City of Surrey
PLANNING & DEVELOPMENT REPORT

Application No.: 7924-0143-00

Planning Report Date: December 16, 2024

- **City Centre Plan Amendment** from Mid to High Rise Mixed-Use to Low to Mid Rise Residential and High Rise Residential – Type II
- **Rezoning** from CD (Bylaw No. 20416) to CD
- **Detailed Development Permit**

SHEET TITLE
SHADOW STUDY

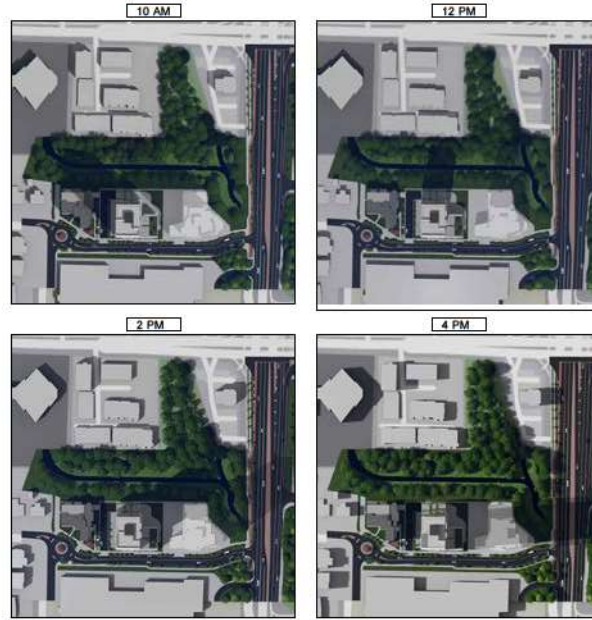
- Consider producing a shadow study to examine how planting will be affected by the cast of the tower.

Shadow study included in DP package, and landscape architect has considered shade tolerant plants on north side of development.

OVERALL SITE PLAN

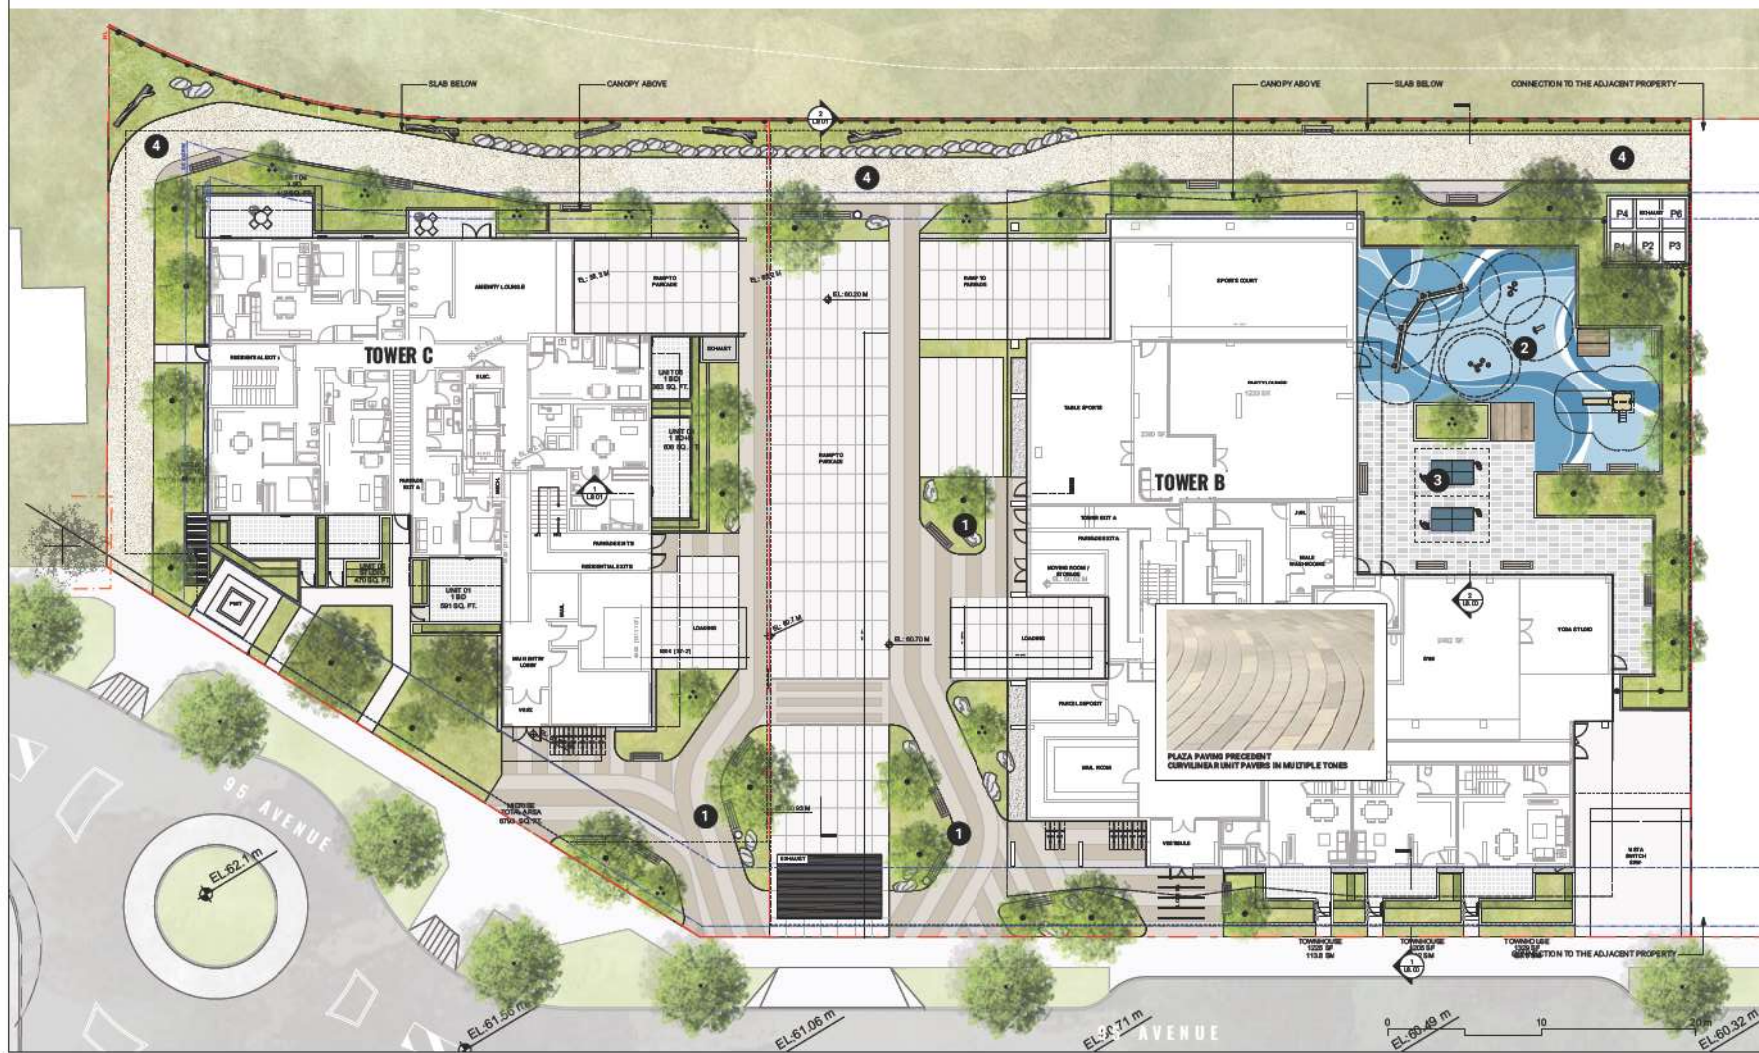
- Recommend reviewing tree and shrub planting design /character to reflect a meander or natural scheme rather than a rigid grid / linear spacing in association with riparian area.

The landscape has been revised to take on a more organic character; gridded planting revised to more flowing nature. Please refer to the Landscape Architects revised drawings showing how the design reflects a meandering or natural scheme in the riparian area.
